ADDENDUM No. 1

PROJECT: Ottawa Elementary School- Freezer Replacement Project
CLIENT: Buchanan Community Schools
ISSUE DATE: 4/3/2023

ELECTRIC RISER PLAN

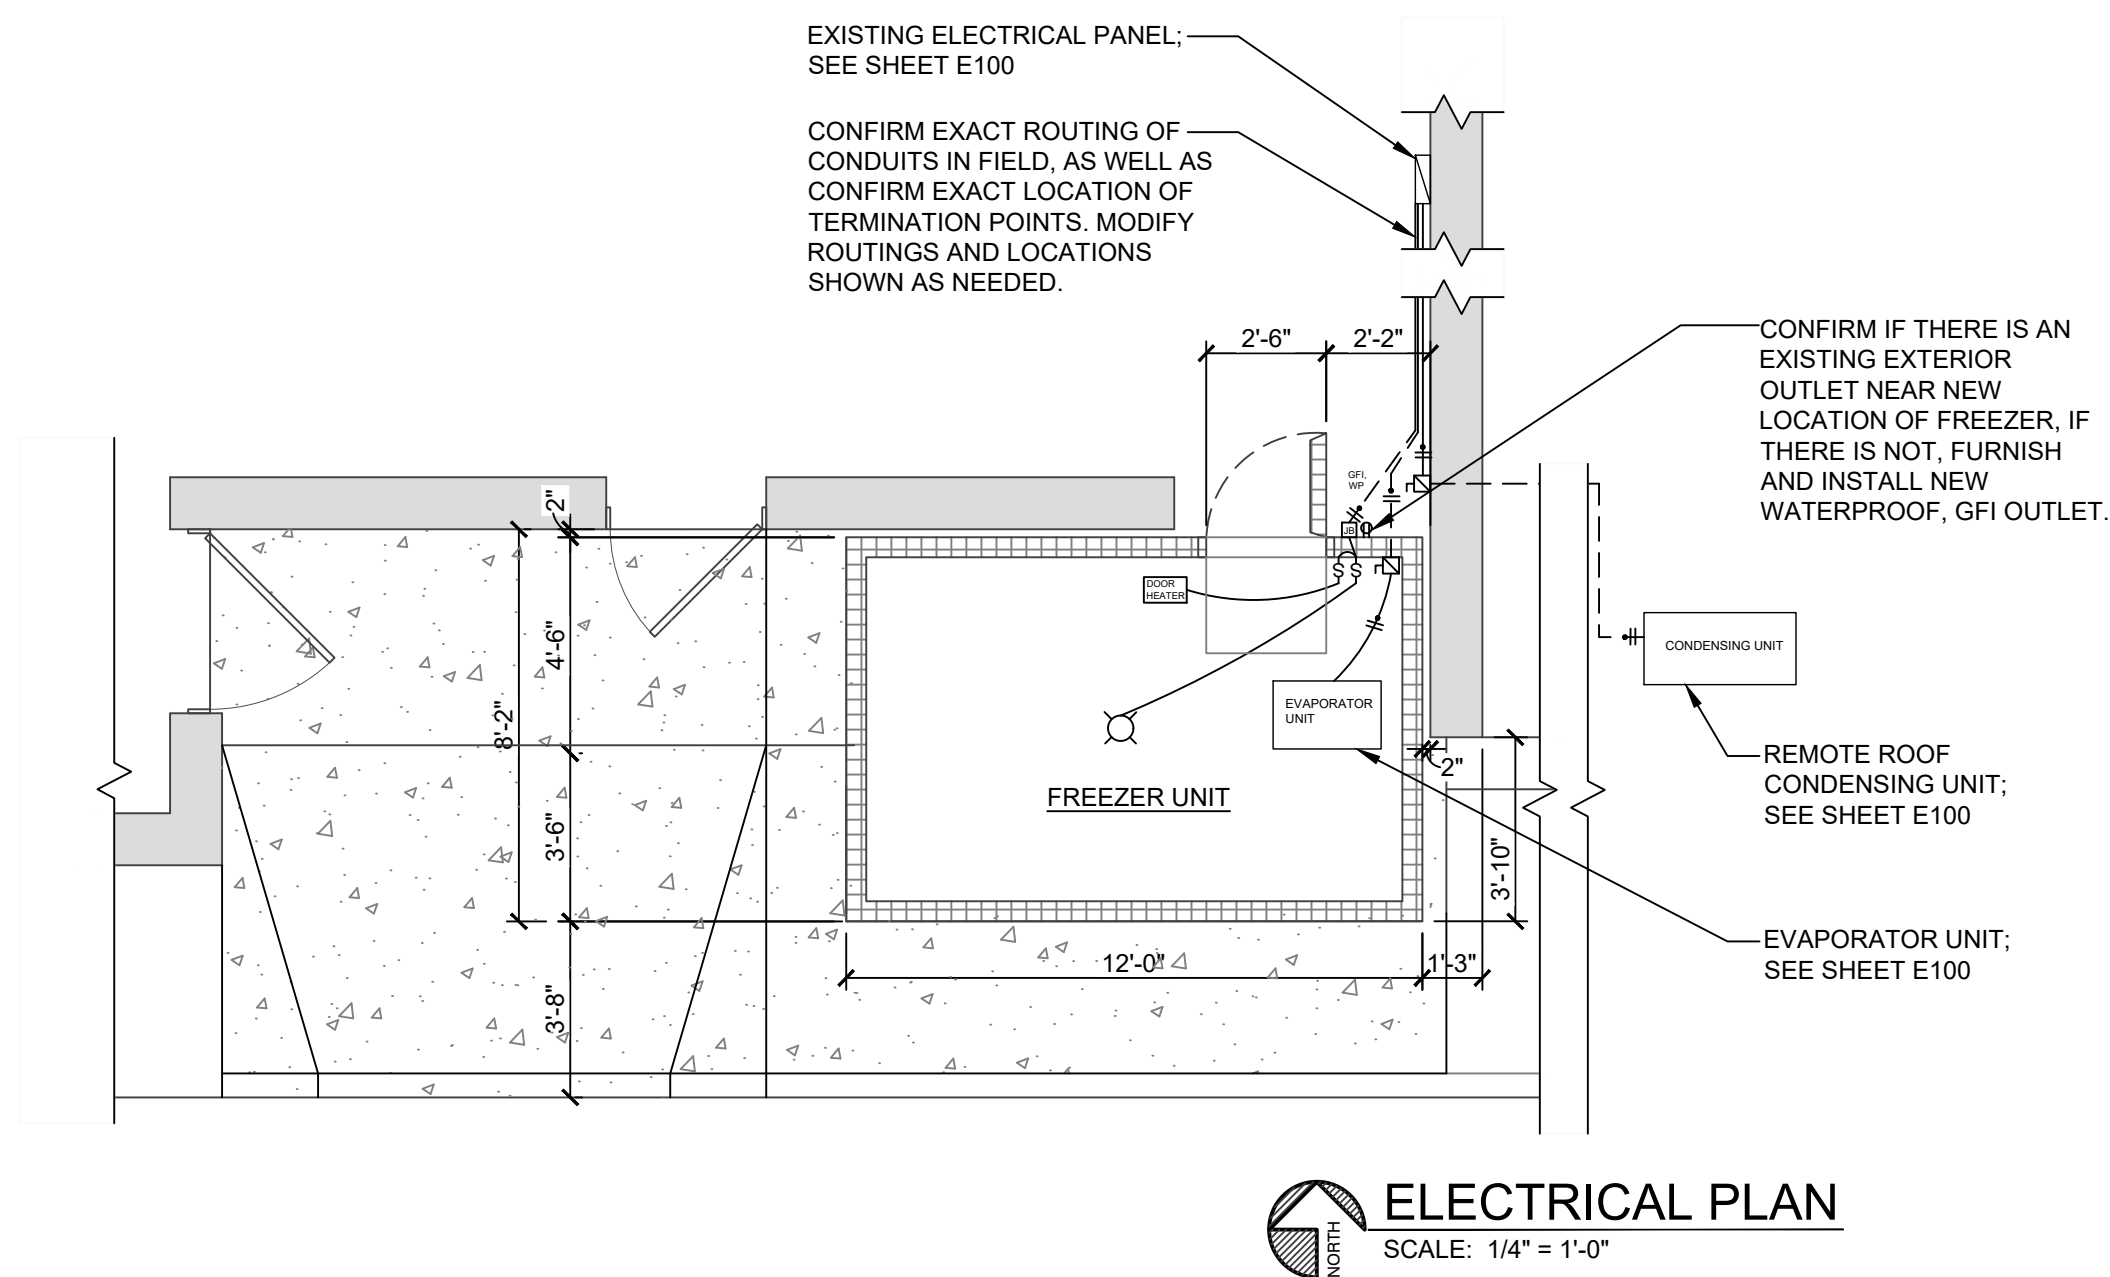
- A question was asked about the location of the electrical panel serving the freezer condenser. The electrical panel that is assumed to supply the condenser was found and there is a line drawing provided on sheet E1 of the architectural drawings, the contractor must verify in field all electrical requirements.
- It was asked if there were drawings from the freezer supplier. The drawings are provided with this addendum.
